SUBJECT: **Safety Recall 11S21 - Supplement #2**
 Certain 1997 through 2003 Model Year F-150, 2004 Model Year F-150 Heritage,
 1997 through 1999 Model Year F-250 Light Duty, and 2002 through 2003 Model Year
 Blackwood Vehicles Operated in Corrosion States
 Fuel Tank Strap Inspection and Repair

REF: **Safety Recall 11S21 – Supplement #1**
 Dated August 18 2011

Safety Recall 11S21 – Supplement #2

New! INSPECTION/REPAIR FLOWCHART

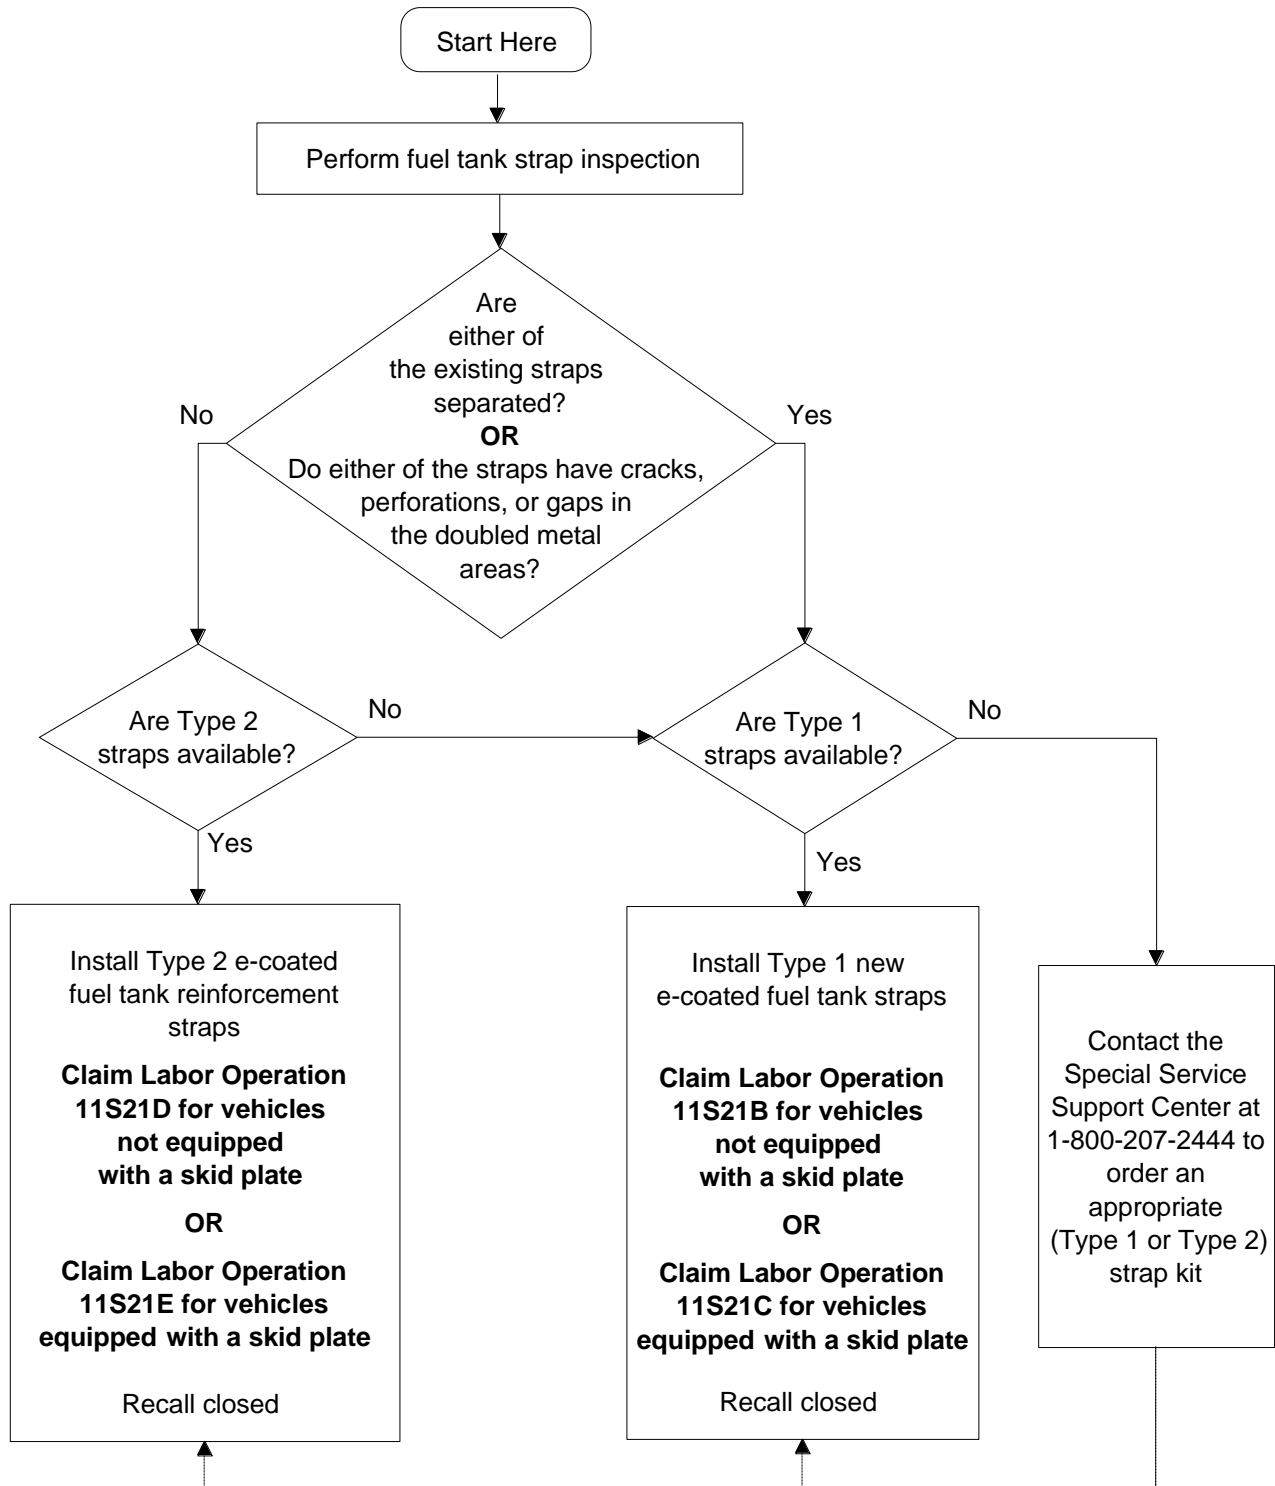
- *Advise dealers that the service action has been updated so that all vehicles, including those equipped with a fuel tank skid plate, can now be repaired. For vehicles equipped with a skid plate, new labor operations (11S21C for Type 1 Straps and 11S21E for Type 2 Straps) will be activated on September 16, 2011.*

Dealers will inspect the fuel tank straps for cracks, perforations, or separations. Based on the results of the inspection and the availability of fuel tank strap kits, dealers will install either Type 1 new E-coated fuel tank straps or Type 2 E-coated fuel tank reinforcement straps. Refer to the Inspection/Repair Flowchart to determine the appropriate type fuel tank strap kit to be used.

NOTE: *Sufficient parts have been sent to dealers to service vehicles as they arrive. Therefore, installation of secondary fuel tank cables now requires prior approval from the Special Service Support Center (SSSC). Labor operation codes 11S21J for inspection and 11S21K for installation of secondary fuel tank cables will be deactivated for repairs dated after September 16, 2011.*
